AGENDA

LOCAL TRAFFIC COMMITTEE MEETING MONDAY 9 DECEMBER 2024

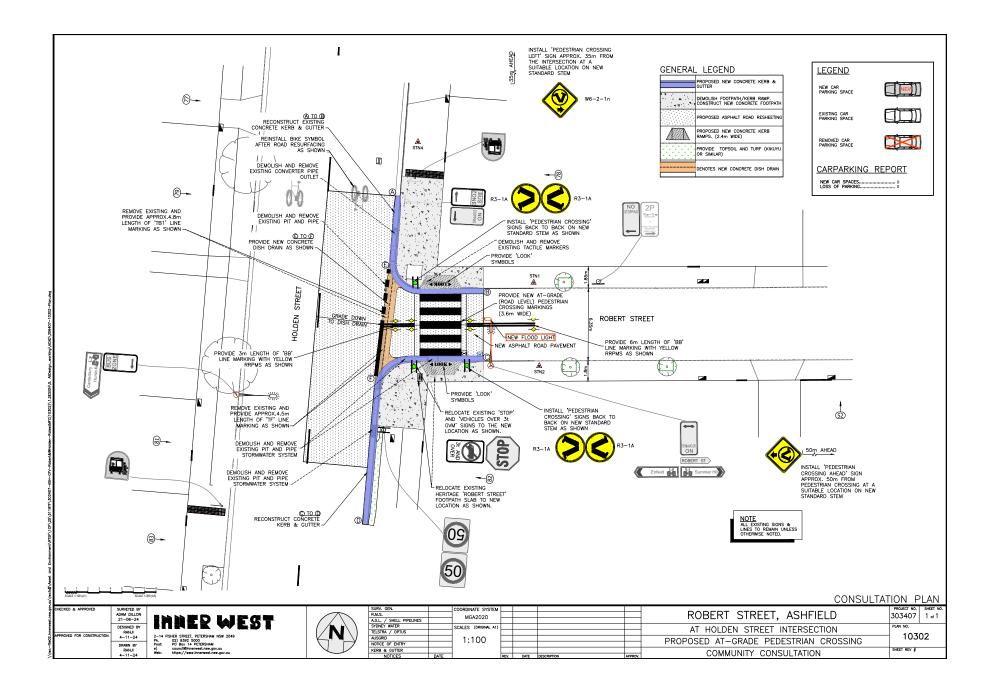
There are high traffic volumes at Holden Street and Robert Street during school and work peak hours. The installation of the zebra crossing would result in vehicles being in the path of the oncoming traffic in Holden Street. The right of way should remain with the turning vehicles and not the pedestrians.

Officers Response
